**CRITICAL AREAS DETERMINATION****NOTICE OF DECISION****April 2, 2018**

<b>Project Number:</b>	CAO17-011
<b>Description:</b>	Request to review a critical areas study and mitigation plan to reduce the wetland buffer to the minimum 25 feet along the western portion of the wetland
<b>Applicant:</b>	David Daniel Demco Law 5224 Wilson Ave S #220 Seattle WA 98118
<b>Owner:</b>	Edith Cropp 4803 Forest Ave SE Mercer Island WA 98040
<b>Site Address:</b>	4810 Forest Ave, Mercer Island WA 98040; Identified by King County Assessor tax parcel number 4045000145
<b>Zoning District:</b>	R-15
<b>SEPA Compliance:</b>	The proposal is categorically exempt from SEPA review per WAC 197-11-800(6)(e).
<b>Exhibits:</b>	<ol style="list-style-type: none"><li>1. Development Application for a Critical Area Determination, signed date July 25, 2017</li><li>2. Critical Areas Study prepared by Confluence Environmental Company, dated November 9, 2017</li><li>3. Peer review memo prepared by ESA, dated October 12, 2017</li><li>4. Critical Areas Study and mitigation plan prepared by Confluence Environmental Company, dated March 6, 2018</li><li>5. Peer review memo prepared by ESA, dated March 19, 2018</li><li>6. Publi

Figure 3. Buffer Reduction and Mitigation Areas

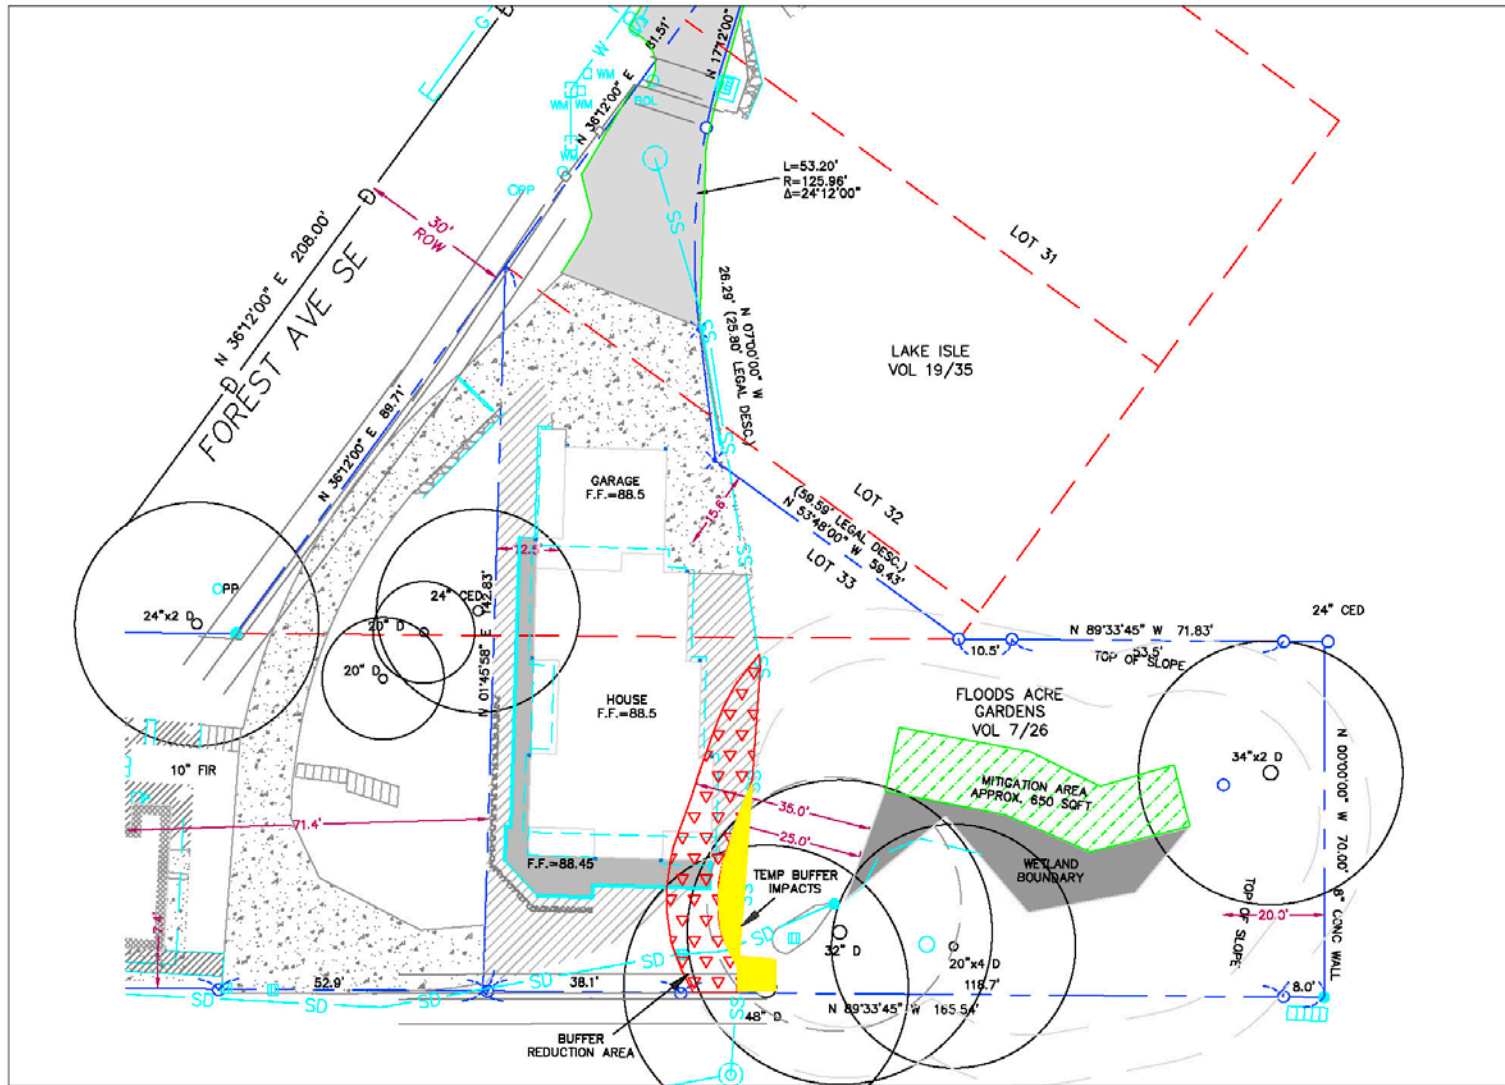
buffer will occur. In order to offset the impacts of the buffer reduction, the applicant proposes to enhance 650 SF of the buffer upslope of the reduced buffer area and within the standard buffer area. Enhancement will include the removal of invasive species including Himalayan blackberry, English ivy, and laurel. Subsequent planting of native shrubs and trees will occur and include Nootka rose, oceanspray, salmonberry, and western red cedar. Temporary impacts to the reduced buffer will be treated with grass seed post-construction and converted to lawn. A detailed 5-year monitoring plan is also included within the Mitigation Plan.

Based on our review, we have determined that the Mitigation Plan is consistent with MICC 19.07.070.2(a). The 650 SF of proposed mitigation planting will offset impacts resulting from the 650 SF of buffer reduction. The area of proposed buffer reduction is downslope of Wetland A and is composed largely of impervious surface, therefore providing little habitat, water quality, or hydrologic buffer function to the wetland. The removal of invasive vegetation and subsequent planting of native species upslope of Wetland A will provide an increase in water quality and hydrologic function of the wetland buffer and provide a lift in habitat function. With successful implementation of the mitigation and monitoring plan the proposed buffer reduction would not result in a loss of ecological functions within Wetland A or its associated buffer.
